STAFF REPORT

SUBJECT: H-2022-0065 – West Valley Emergency Center – MDA, CUP, ALT

LOCATION: Southwest corner of N. Levi Ln./N. Rustic Oak Way, in the NW ¼ of Section 28, Township 4N., Range 1W. (Parcel #R699122250)

C. Site Plan (dated: 9/29/2022)

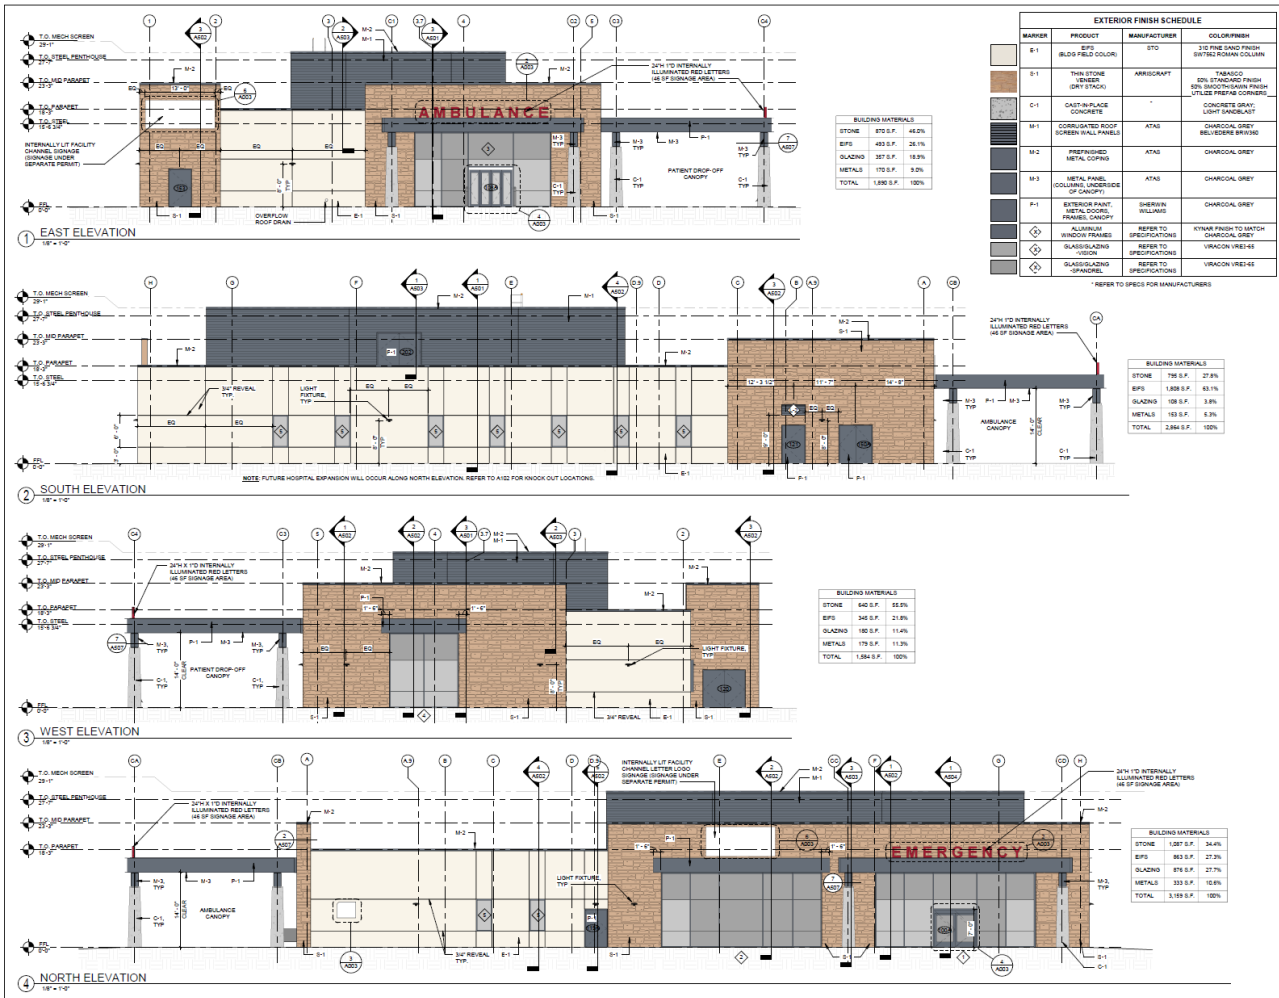
- 1.1 Extend 8" water main to area of hydrant and then install the 6" lateral and hydrant. See mark up on sheet C-3.0. This would also allot the fire line and water meter runs to be shorter.

- 1.2 Both the fire hydrant lateral and the Fire line are called out as "Fire Lines". Call them out differently as the fire hydrant lateral is public and requires an easement where the fire line is private and does not require an easement.

- 1.3 The fire hydrant lateral has a tee. No other item can connect to an 6" fire hydrant lateral except a single hydrant. So tee would not be allowed.

- 1.4 Provide a 20' easement for the water line, fire hydrant lateral, and service up to the meter. Extend easement 10' beyond the hydrant and water meter.
